Application for Works Approval Amendment

Works Approval Number	W6427/2020/1
Works Approval Holder	Fremantle Port Authority
File Number	DER2020/000324
Premises	Kwinana Bulk Terminal Riseley Road, NAVAL BASE WA 6165 Legal description Lot 452 on Deposited Plan 220690, Part of Lot 11 on Deposited Plan 39572 and Lot A within Lot 251 and Lot C within Lot 250 on Deposited Plan 415974
Date of Report	14 July 2022
Decision	Revised works approval granted

FPA Infrastructure Upgrade & Cockburn Cement Lease Area

Figure 1: Amended location and detail of proposed upgraded infrastructure

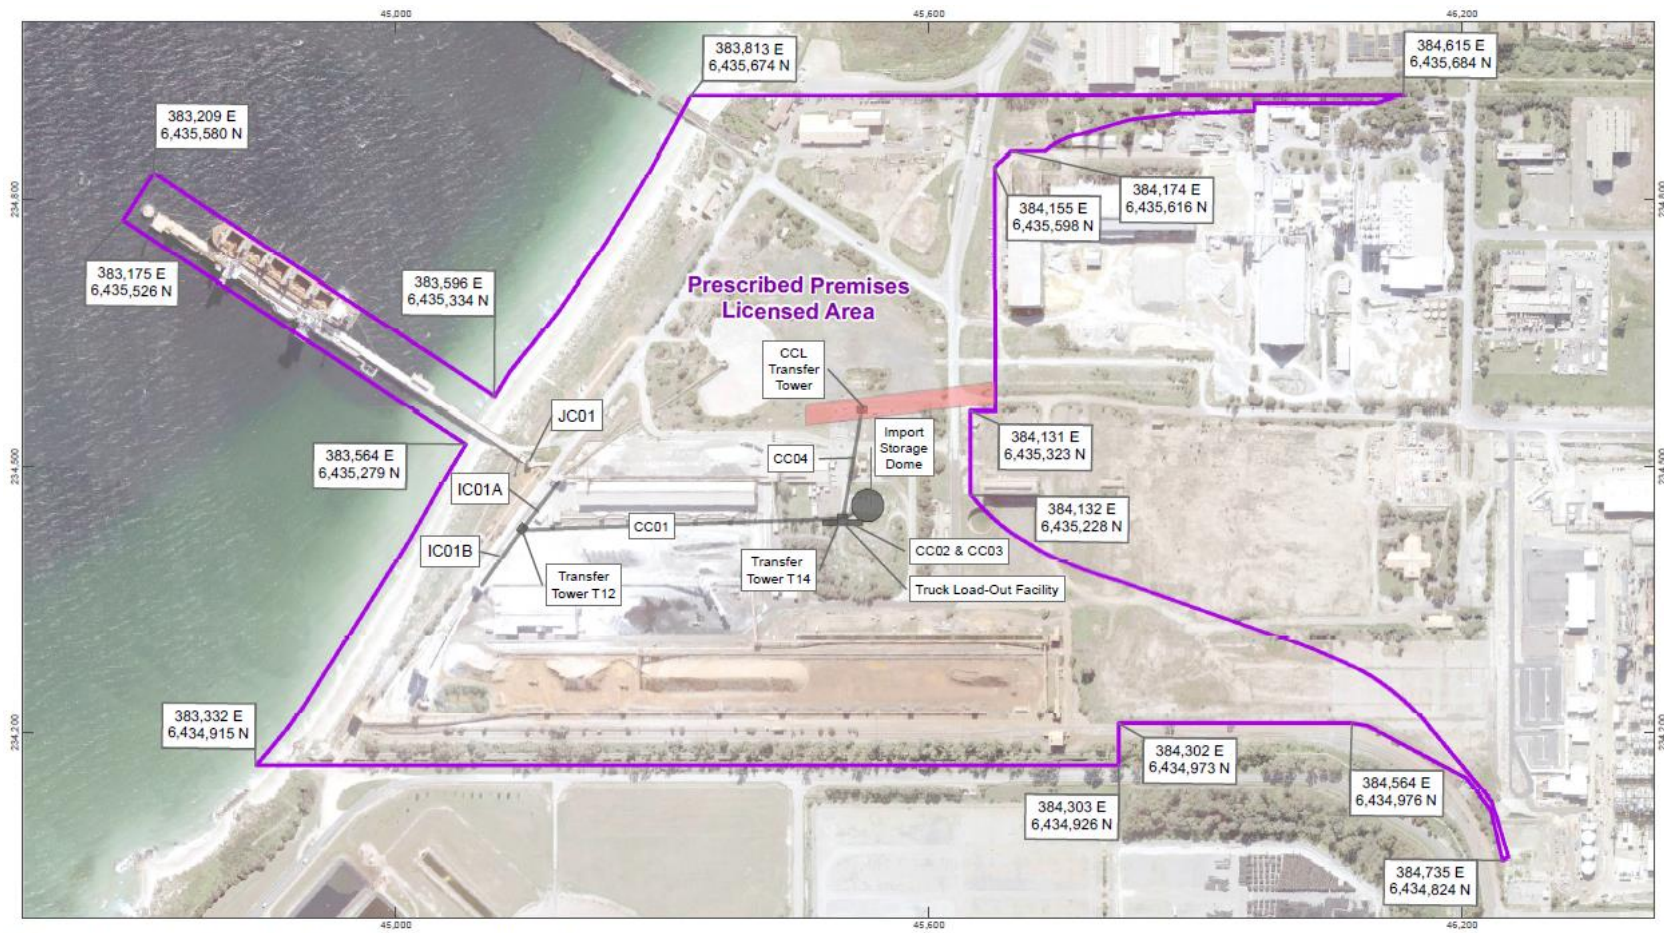
From W6427/2020/1, the main change is the removal of transfer tower CC01/EC01, and the planned upgrade of EC01. The Works Approval Holder now propose to run conveyor CC01 from transfer tower T12 through to import storage dome transfer tower T14, reducing the number of transfer towers by 1, and no longer requiring the upgrade of conveyor EC01.

The original storage shed is now to be a fully enclosed import storage dome with the same capacity of 40,000 tonnes, and the storage capacity of the truck loadout system is increasing from 110 tonnes to 200 tonnes, refer to Figure 1.
